**DEPARTMENT of ENVIRONMENT
and NATURAL RESOURCES**

Re: Wharf Resources Large Scale Mine Permit Application

Staff review continues on Wharf Resources' permit application for the Wharf Expansion Project which was submitted February 18, 2011 and supplemental information submitted July 5, 6, 7, and 14, 2011. Based on this review, the department has generated the following technical comments:

June 2011 Application Revision 1.0

DENR TECHNICAL COMMENTS--FIGURE 2

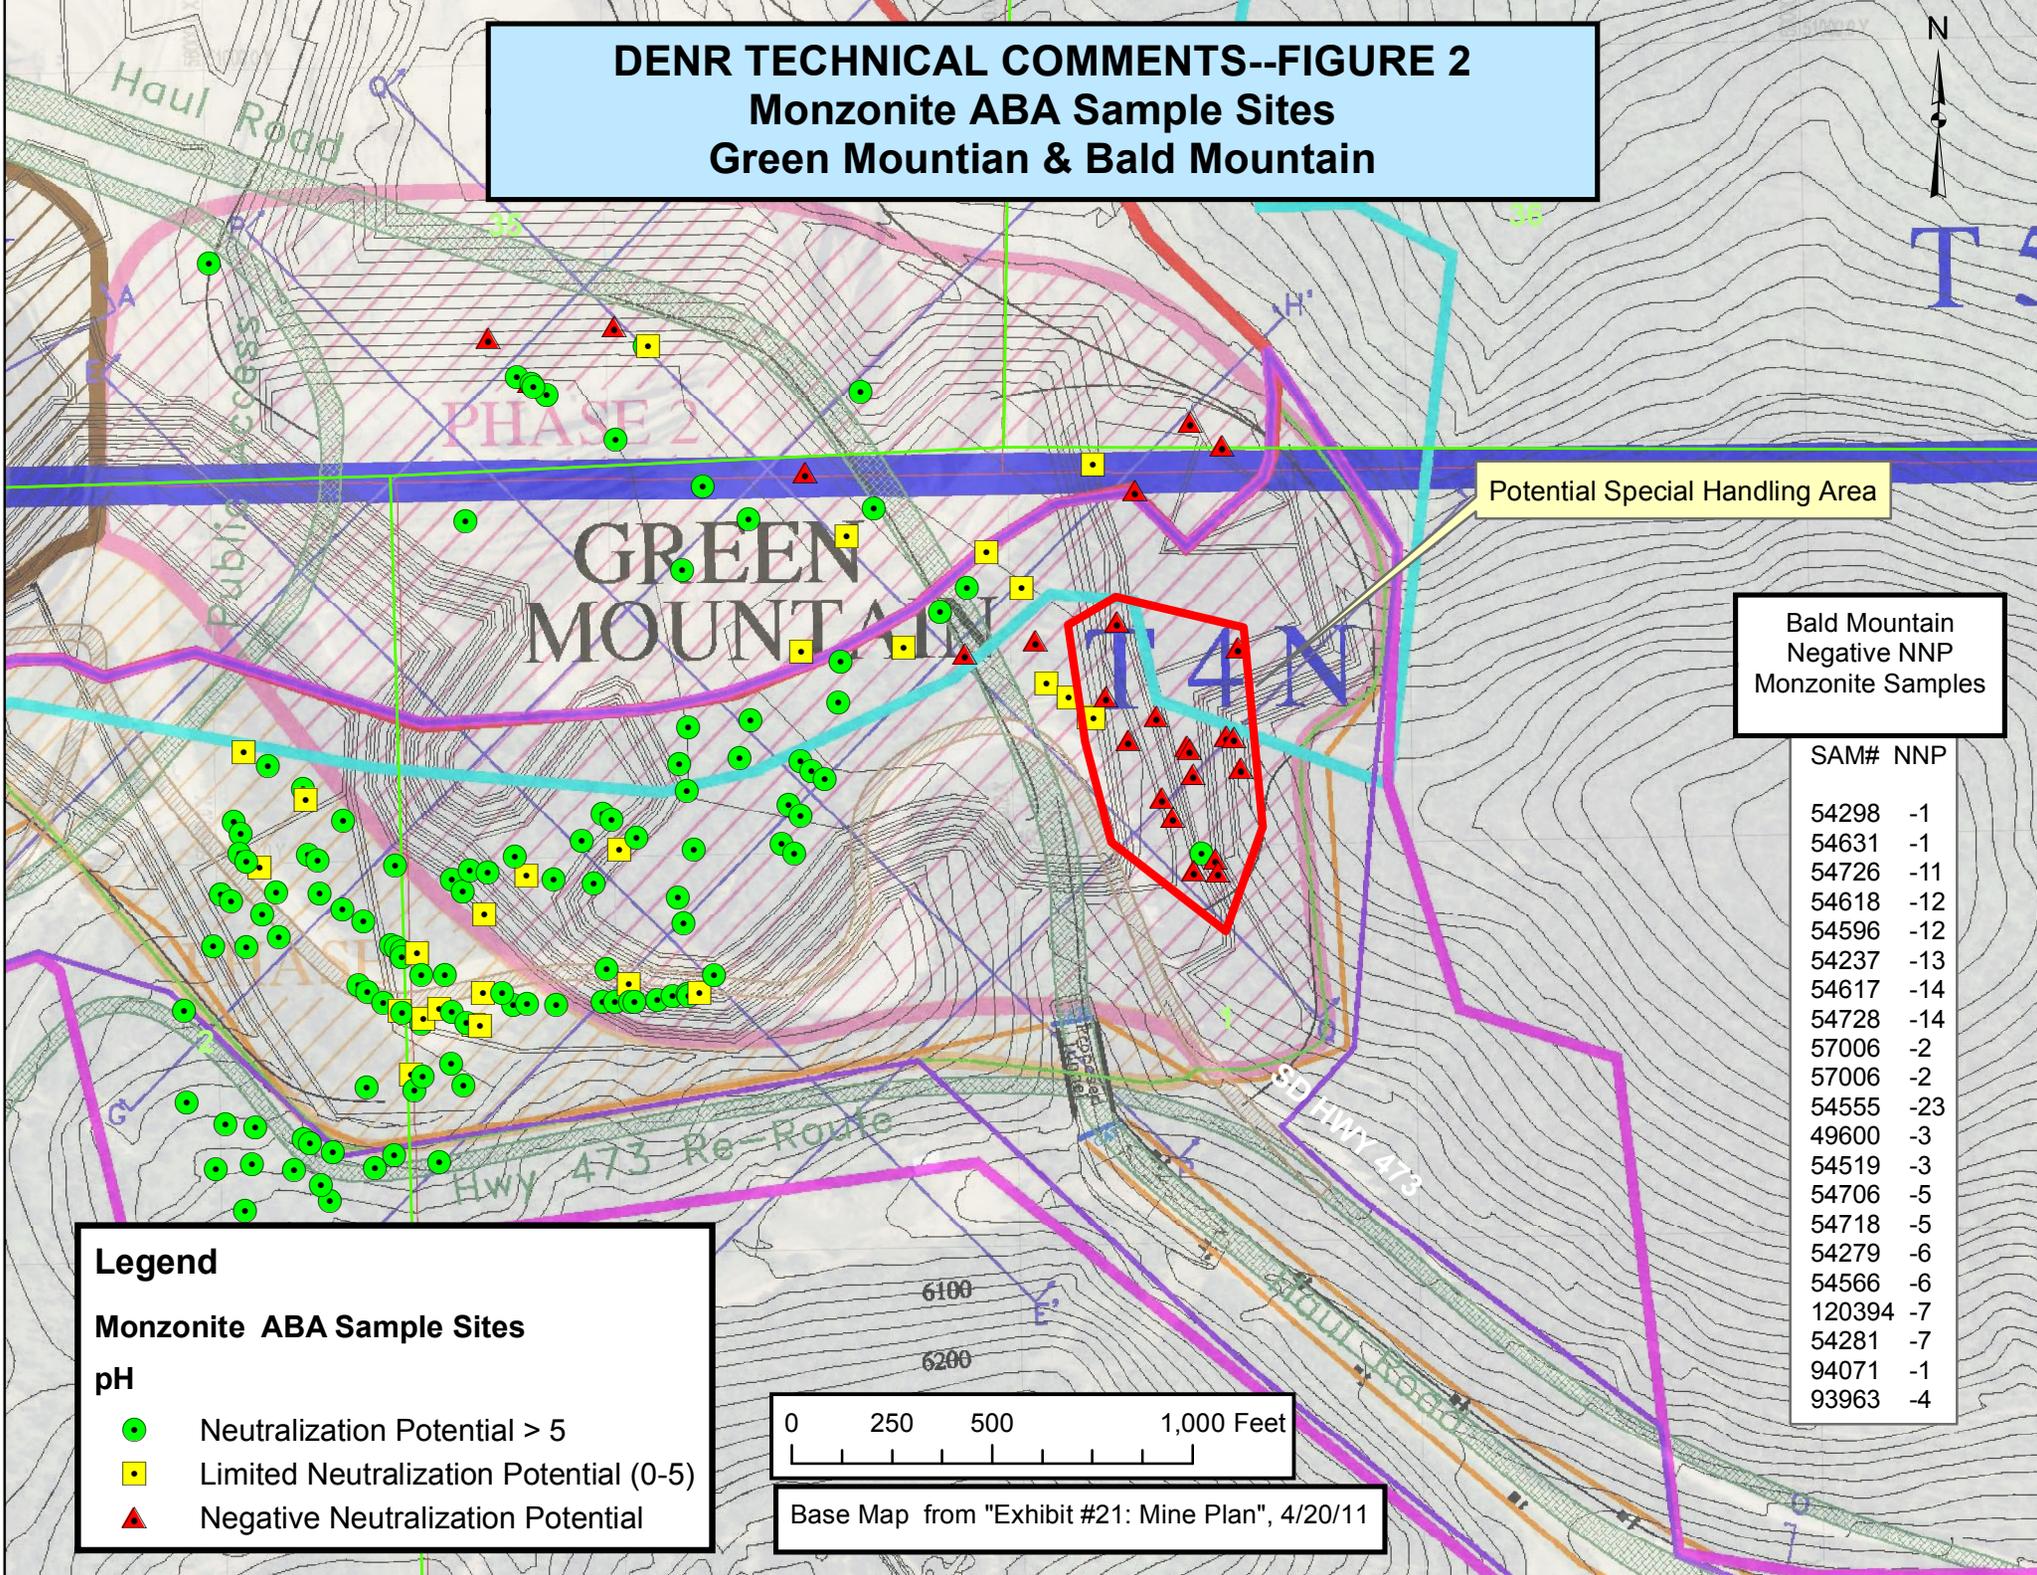
Also, Wharf states “The Green Mountain area overall has a very large NNP and NP:AP ratio within all rock types to be mined, with a low nonsulfate sulfur content indicating low ARD potential. There are random hits within the pit boundary that indicate a potential for ARD under the California criteria, but these samples are isolated and not clustered together. The Green Mountain Pit took into consideration the ARD potential of the Deadwood lower contact when the pit was designed so as not to include any clusters of ARD potential material. Much of the ARD material was located on the eastern edge of the pit along Bald Mountain where the Deadwood lower contact comes in contact with the Precambrian rocks; in this area the pit was finalized above these areas so as not to mine any ARD potential material.” This assessment appears to be inconsistent with the ABA data and maps submitted with the revised application (June, 2011). There appears to be a significant cluster of acid generating samples associated with both the intermediate Deadwood and the monzonite sill underlying the western slope of Bald Mountain (see *Figure 2 Monzonite ABA Sample Sites Green Mountain and Bald Mountain* and *Figure 3 Intermediate Deadwood ABA Sample Sites Green Mountain and Bald Mountain*). Most of these acid generating samples were classified as “in pit”. Wharf needs to either address why Deadwood sediments and the monzonite underlying the saddle between Green Mountain and Bald Mountain were not identified as Special Handling Material (SHM), or designate material in this area as SHM. Wharf also needs to identify how much acid generating material they plan to remove from this area.

In addition, Wharf states, “The Green Mountain Pit took into consideration the ARD potential of the Deadwood lower contact when the pit was designed so as not to include any clusters of ARD potential material. Much of the ARD material was located on the eastern edge of the pit along Bald Mountain where the Deadwood lower contact comes in

contact with the Precambrian rocks; in this area the pit was finalized above these areas so as not to mine any ARD potential material.” Exhibit #6 (Current Green Mountain Geologic Cross Sections—4-18-2011), cross section I – I’ appears to be inconsistent with this plan to finalize the pit bottom above lowest horizon of the lower Deadwood.

Finally, Cross Section I – I’ appears to transect a cluster of potentially acid generating lower Deadwood sample sites along the western flank of Bald Mountain. The ABA data tables submitted in June, 2011 classify most of these potentially acid generating sample sites as “below pit”, which is consistent with the plan to finalize the pit above the lowest horizon of the lower Deadwood. However, Cross Section I-I’ indicates that the pit floor will be mined down to the Precambrian contact across most of the western flank of Bald Mountain. The apparent discrepancy between Exhibit 6, Cross Section I – I’ and this narrative needs to be reconciled.
